ADDENDUM NO. 1

February 5, 2019

This Addendum supplements and amends the original Plans and Specifications and shall be taken into account in preparing proposals and shall become a part of the contract documents.

**MUSOM
BOILER AND CHILLER
REPLACEMENT**

E1

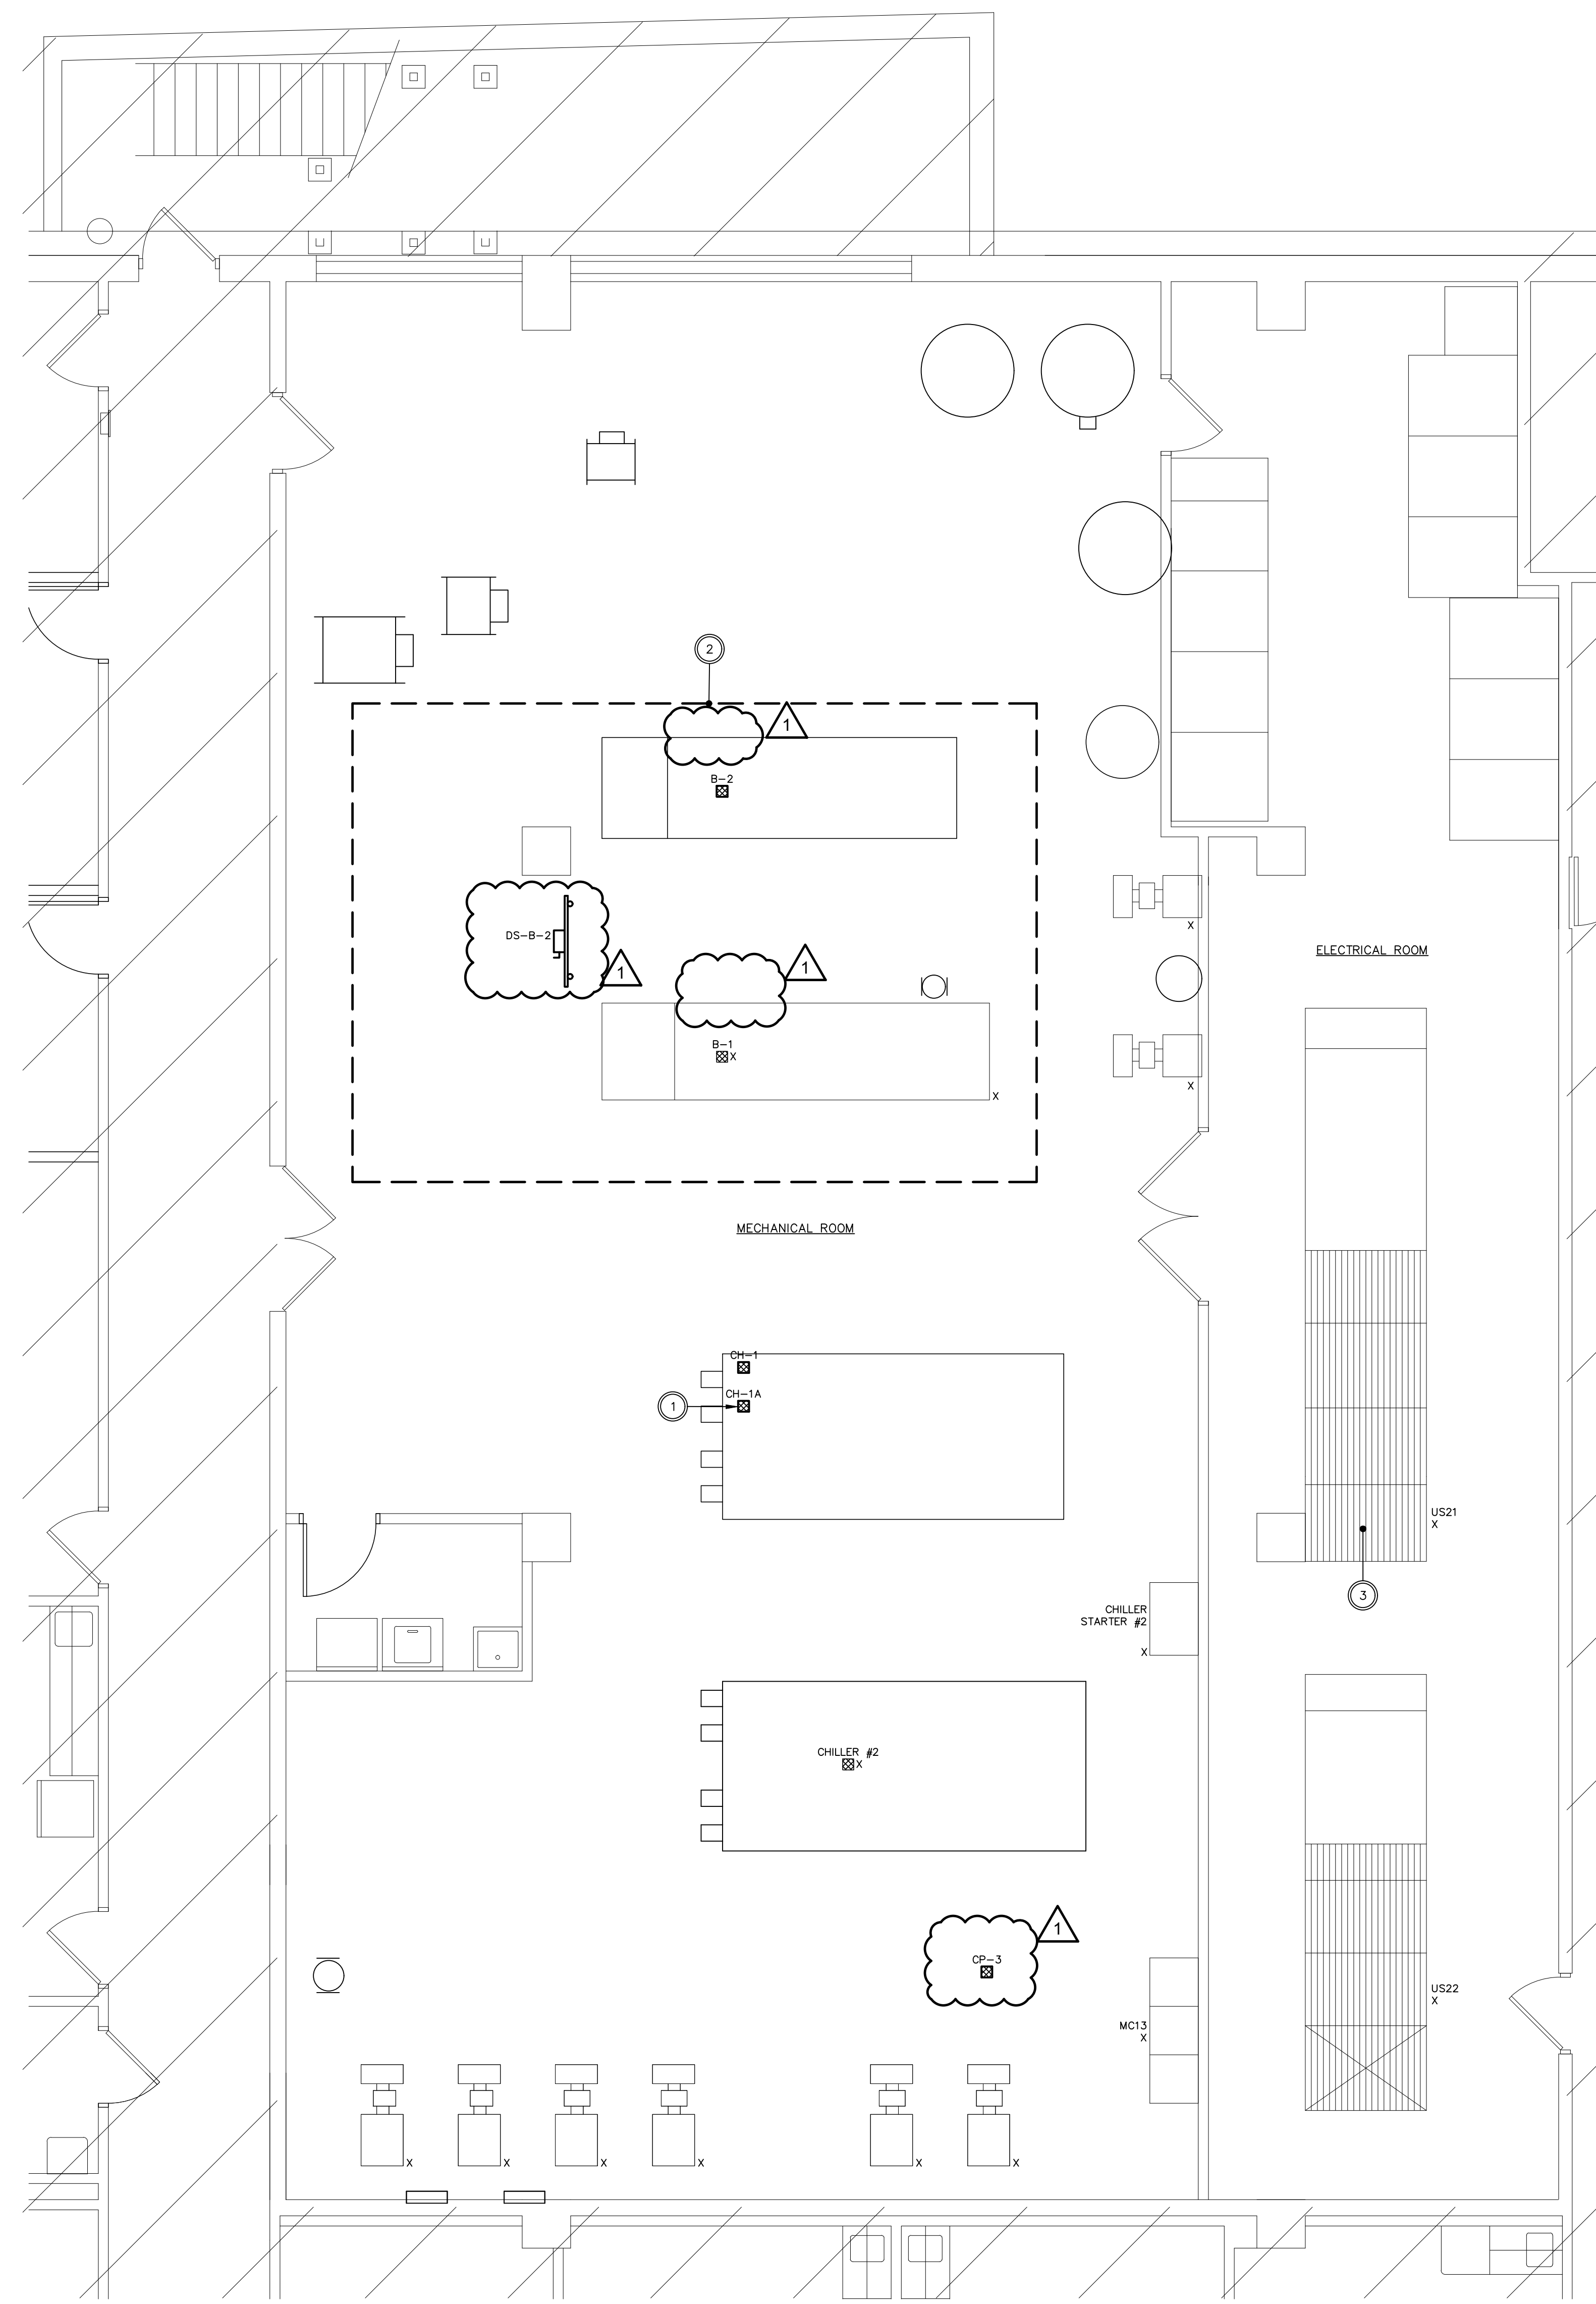
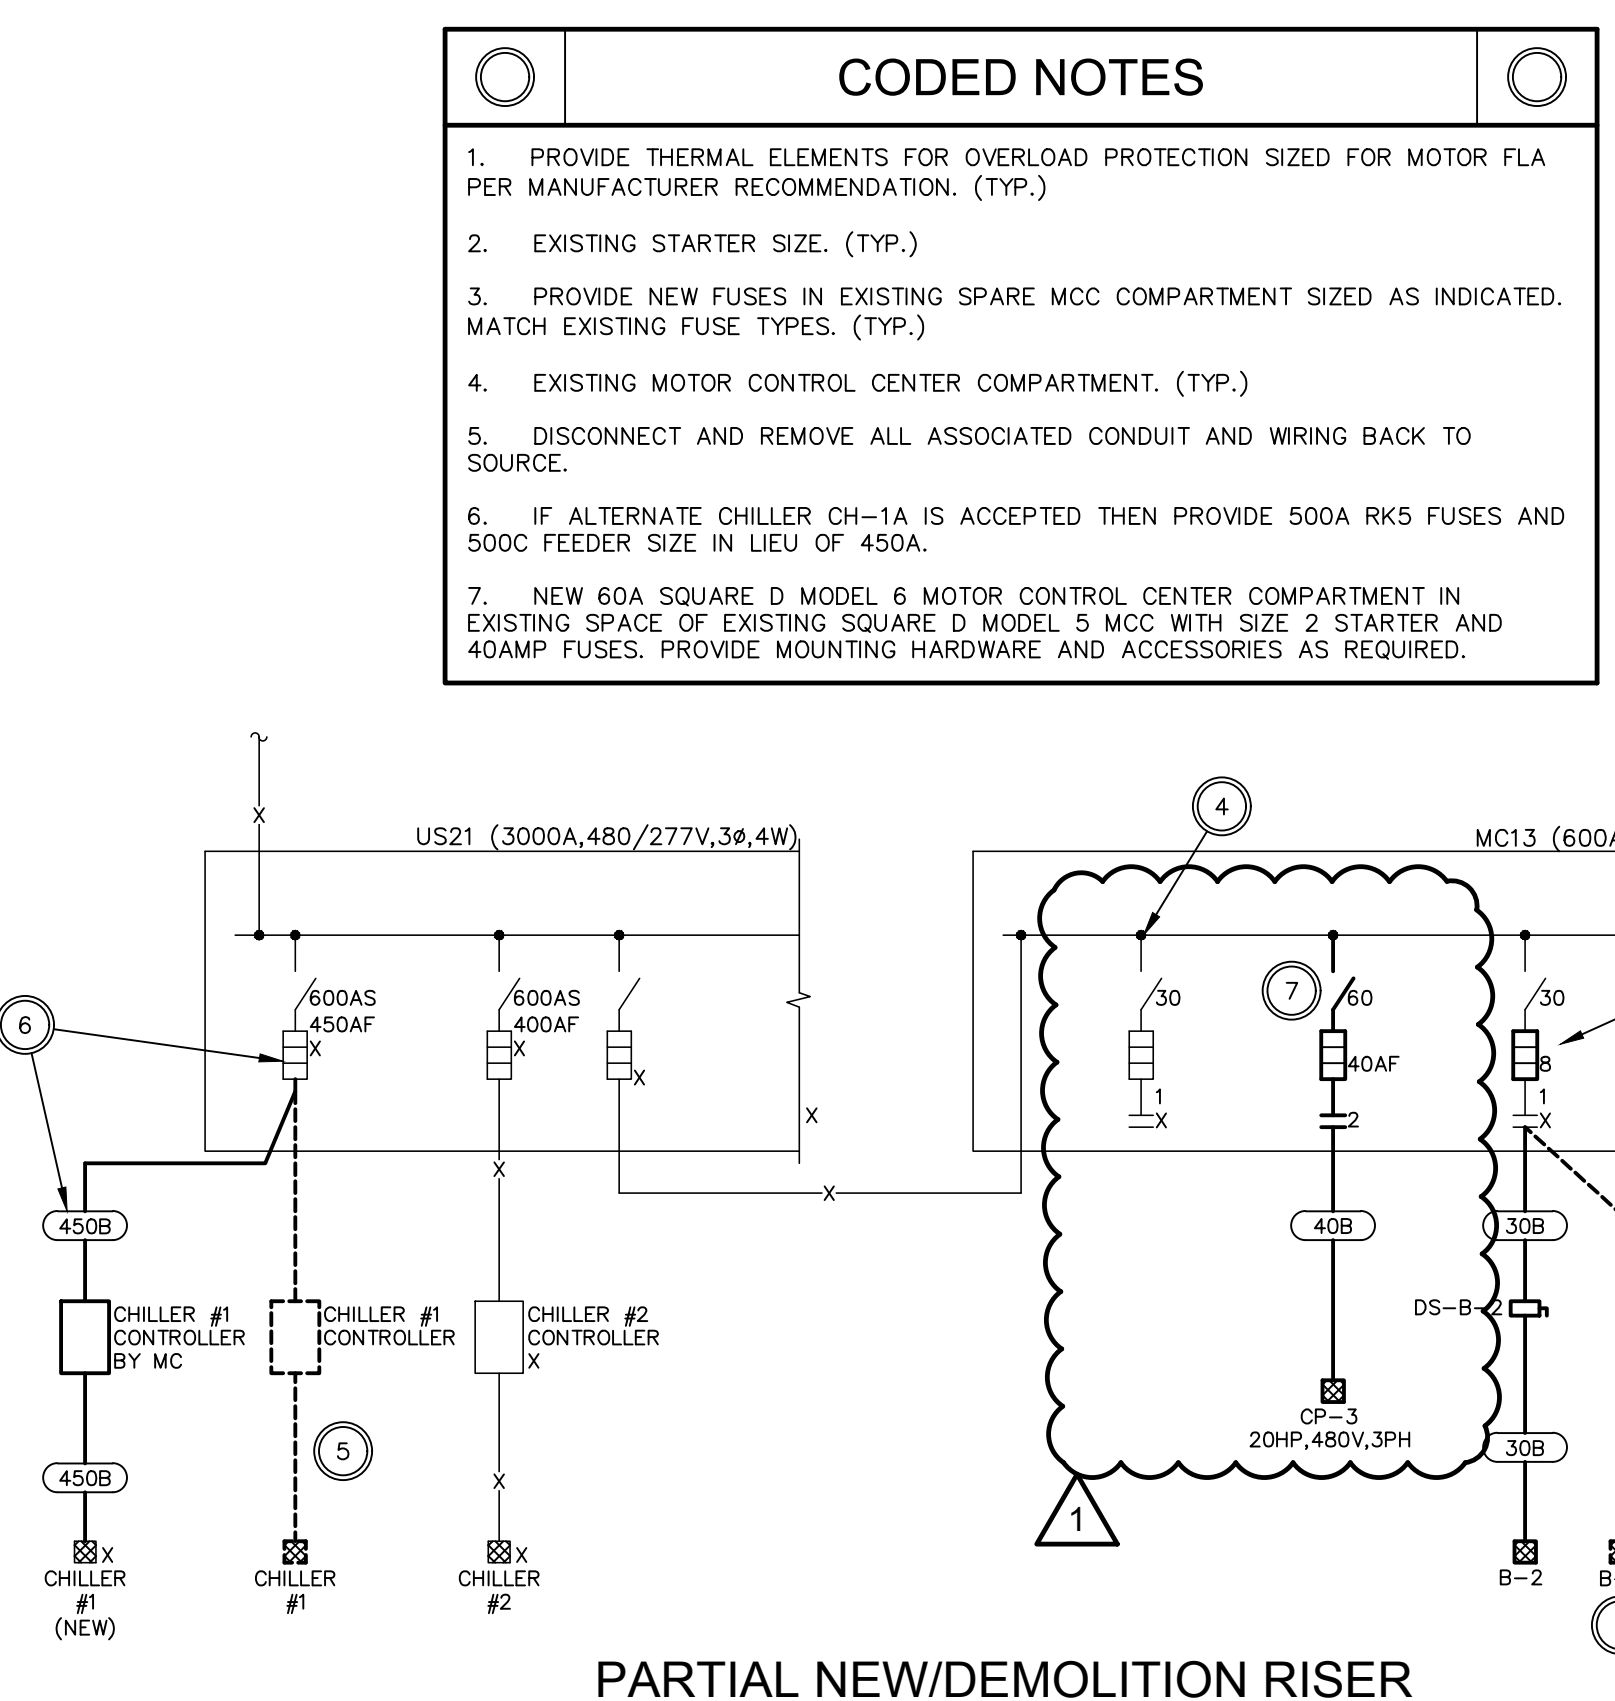
ITEM 16 Sheet E1 "Notes, Legends, Details – Electrical"

- Refer to attached revised sheet E1 for modifications to remove BP-1 & BP-2 and add CP-3.
- Mechanical Equipment Schedule shows the feeder for CH-1 as 450B and CH-1A as 500B. These are feeder size designations per the Standard Feeder Schedule also on Drawing E1.
- Coded Note 6 shows the feeder for CH-1 as 450A and CH-1A as 500C. 450 A and 500 A are fuse sizes in Amps NOT feeder sizes. Codes note 6 is referencing the change in fuse sized required by the change in chiller under Alternate.
